BOSTON EDISON COMPANY  
DOCKET NO. 50-293  
PILGRIM NUCLEAR POWER STATION  
AMENDMENT TO FACILITY OPERATING LICENSE

Amendment No. 82  
License No. DPR-35

SAFETY EVALUATION BY THE OFFICE OF NUCLEAR REACTOR REGULATION  
SUPPORTING AMENDMENT NO. 82 TO FACILITY OPERATING LICENSE NO. DPR-35  
BOSTON EDISON COMPANY  
PILGRIM NUCLEAR POWER STATION  
DOCKET NO. 50-293

**FIGURE 3.6.1**  
**PILGRIM REACTOR VESSEL**  
**PRESSURE - TEMPERATURE LIMITS**  
**HYDROSTATIC AND LEAK TESTS**

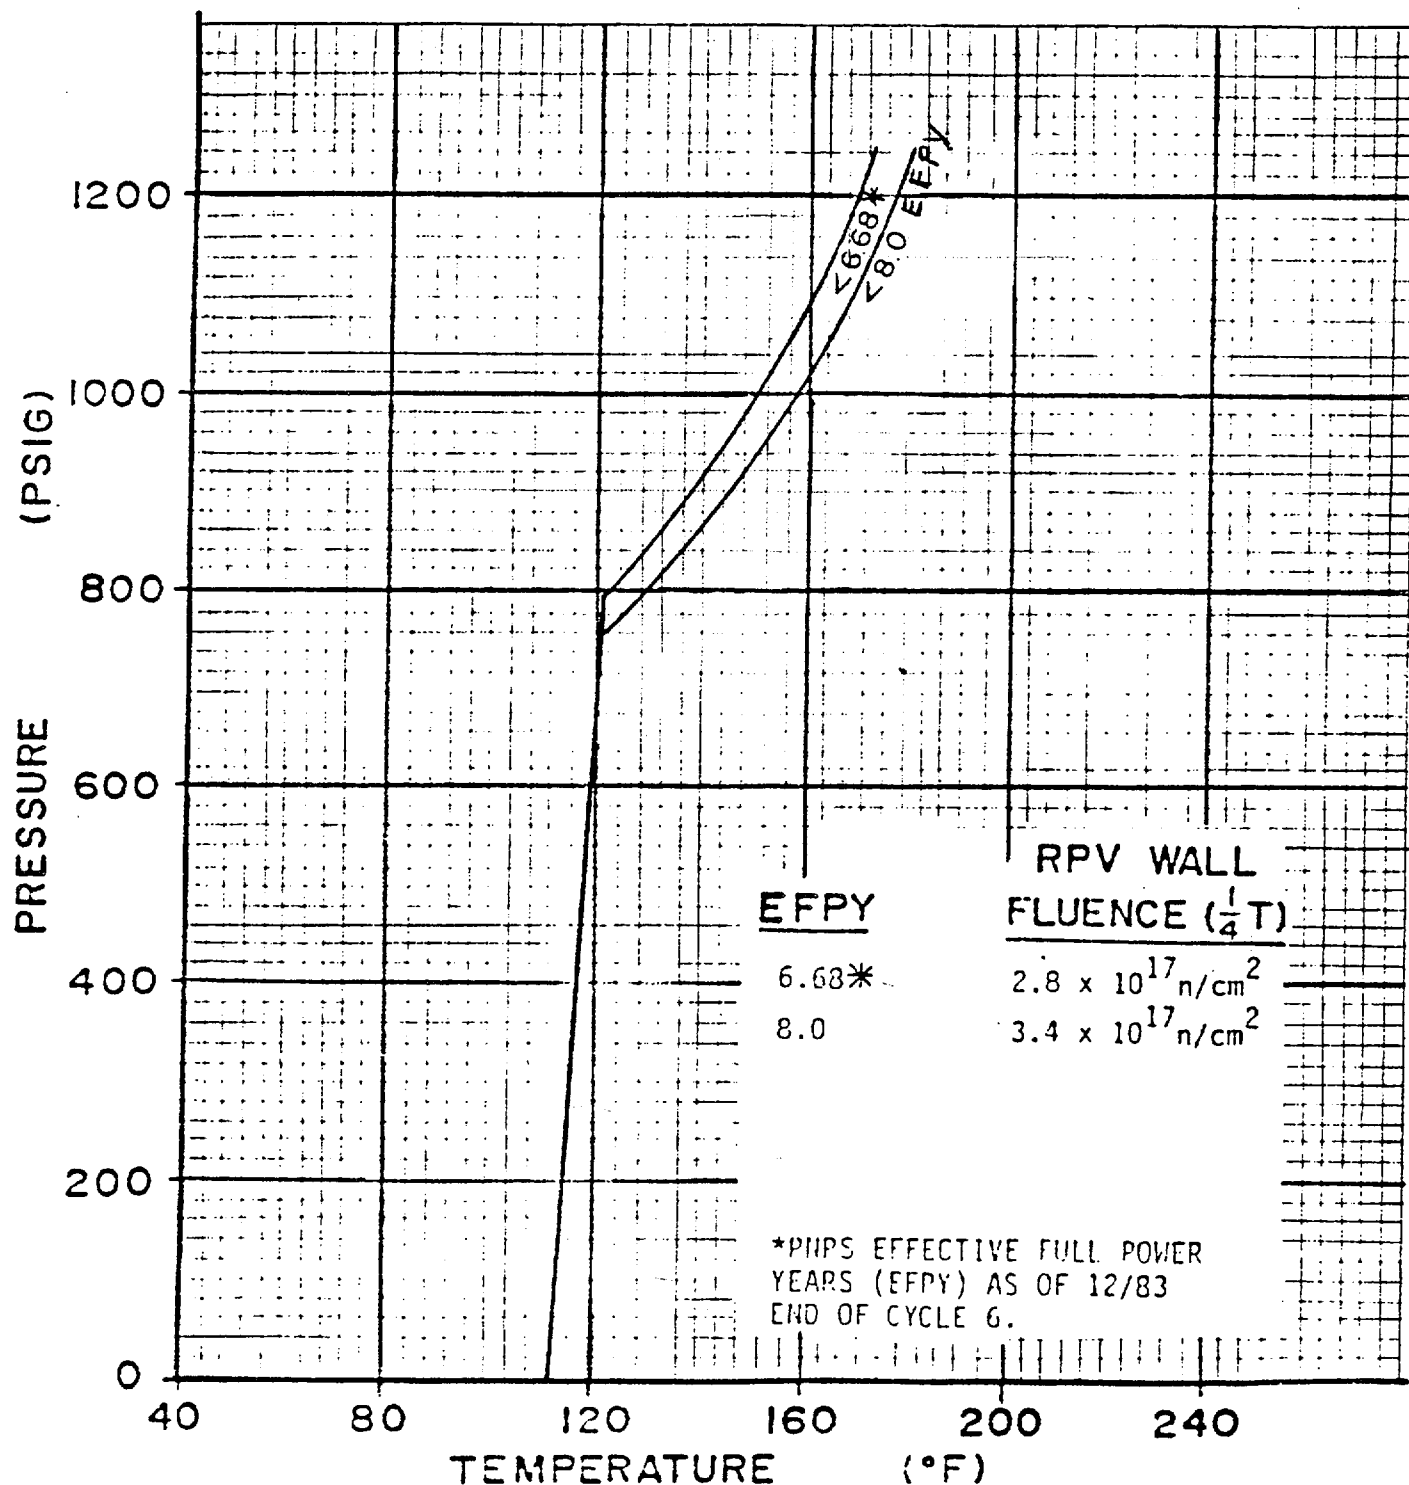
These changes to the Technical Specifications add the schedule for withdrawal of material surveillance capsules from the reactor pressure vessel (RPV). They also revise the RPV thermal and pressurization limit curves to reflect the RT<sub>NDT</sub> shift determined from actual testing of the first capsule removed. The adjusted curves included in this amendment are for 6.68 and 8.0 effective full power years of reactor operation. Subsequent periods of operation will be addressed in a future licensing action. The related limiting condition for operation (LCO) has also been modified to require the operator to take certain actions if the thermal and pressurization limits are not met.

The pressure temperature limit curves proposed by the licensee are more conservative than those in the existing technical specification. Hence, the proposed curves provide more margin against brittle fracture of the reactor vessel than the curves presently in the Pilgrim technical specification. This additional margin permits us to conclude that the Pilgrim reactor vessel may be operated using the proposed curves marked 8 EFPY until the next refueling outage; i.e., shutdown following the end of cycle. Additional closure flange and beltline region materials data must be provided by the licensee prior to the next refueling outage to permit us to complete our evaluation of the remaining curves proposed by the licensee.
